PREVOST

**WARRANTY
BULLETIN**

Wb00-10

DATE : MARCH 2000	SECTION :	06 - Electrical
EXPIRATION: MARCH 2001		
SUBJECT : WATER SEEPAGE IN FRONT ELECTRICAL COMPARTMENT

FIGURE 1 : MARKER LIGHT

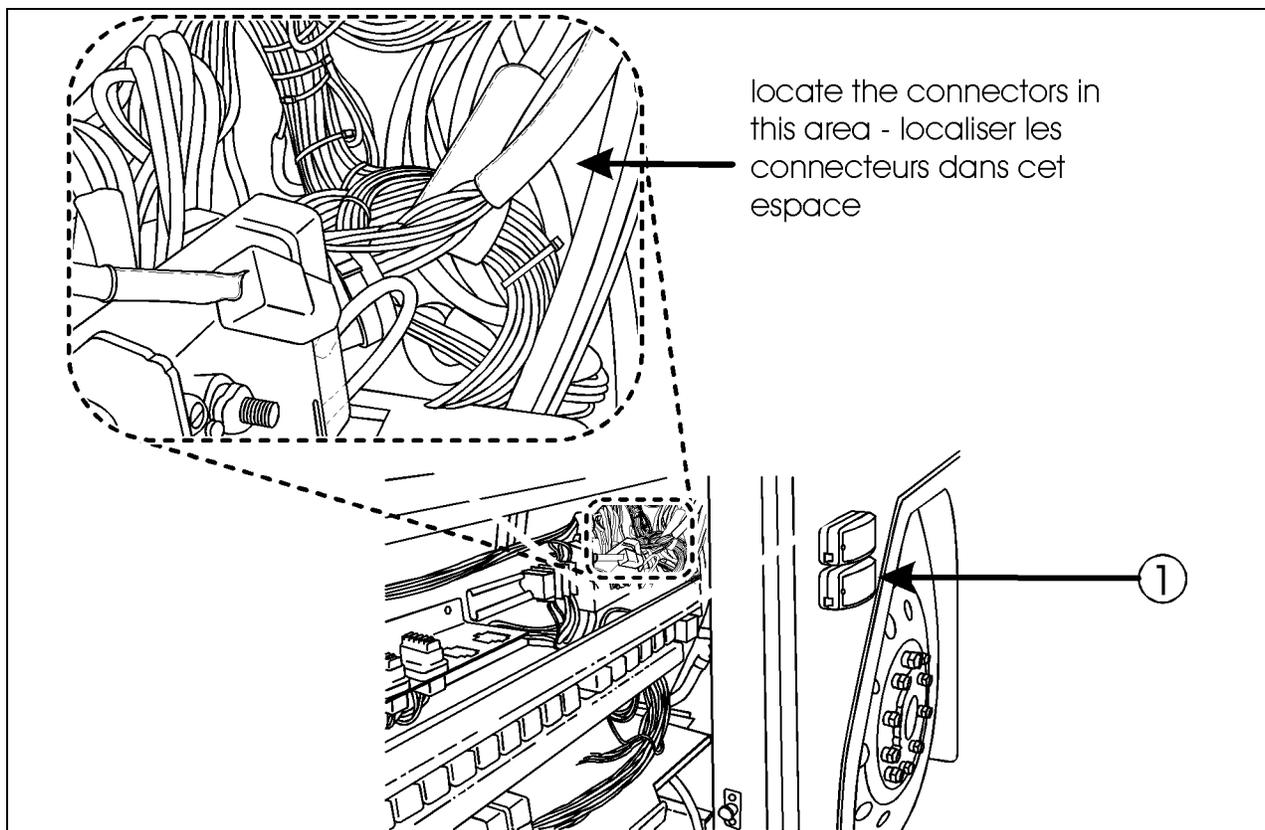
On the above mentioned vehicles, it is necessary to protect some connectors in case of water seepage.

1. Locate the two marker lights beside the front electrical compartment. Dismount the lower one (item figure 1).
2. Check the water tightness of the cable grommet, apply Sikaflex or a silicone sealant.
3. Open the front electrical compartment door. Referring to figure 1, check if there is water in the area behind the marker lights.
4. In the same area, connectors (C45, C500, C506, etc.) must be fastened to a nearby wire harness to keep them off the floor and out of humidity (figure 1). Use cable ties.
